Pepper 010000 Construction Tolerance & Bldg Skin - 01 01-31-2017

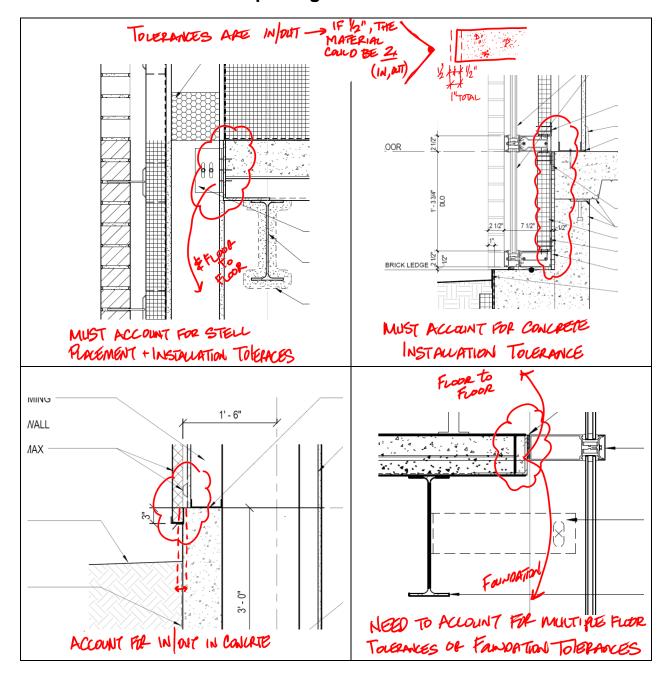
When reviewing Design Development or Construction Drawings, we should be making sure that the Architect has given the skin proper construction tolerance when placing the materials...

Concrete and steel goes in/out and up/down, and the building skin material must accommodate this construction installation. Also discuss live load deflection.

I suggest that we need at least 1" between floor/slab/foundation edges
